## CLASS II PERMISSIVE CHANGE OF PRESENTLY AUTHORIZED EQUIPMENT

Grantee Code : **PWV**  
FCC ID : **PWVW202ER**  
Product Name : **ADSL Modem**  
Model Number(s) : **W202ER & W202ES & W202 &  
W708EUR & W708EU & W708**

GRANT of Certification : **08 / 13 / 2003**  
Product Options : **Addition & alteration of part(component) for  
authorized equipment.**

### 4. Mainboard front view

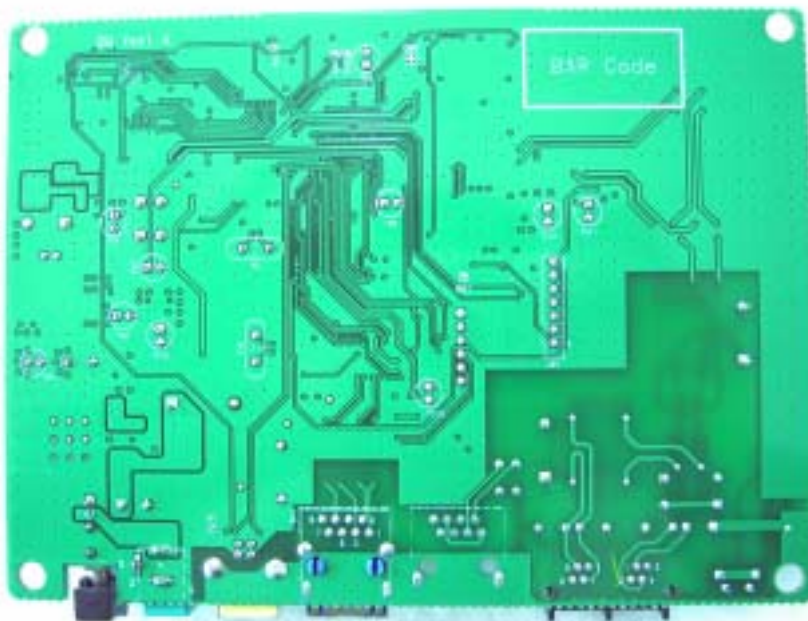
- In comparison with to origin authorized equipment  
as below ;
  - Addition & alteration of part (component)
  - Reference next page

| NO  | Comp. Name     | Design name | Item Code           | Remove | Added  | Change                                       | Q'ty |
|-----|----------------|-------------|---------------------|--------|--------|----------------------------------------------|------|
| 54  | Chip Resister  | R26         | 187 KR              |        |        | Change From 475KR to R174KR                  | 1    |
| 64  | Inductor       | L4          | 10 Uh               | L4     |        | Delete                                       | 0    |
| 70  | Diode          | D13         | 1n5391,<br>50V/1.5A |        | D1,D13 | D1 Change From 1n4001 to 1n5391<br>D13 added | 2    |
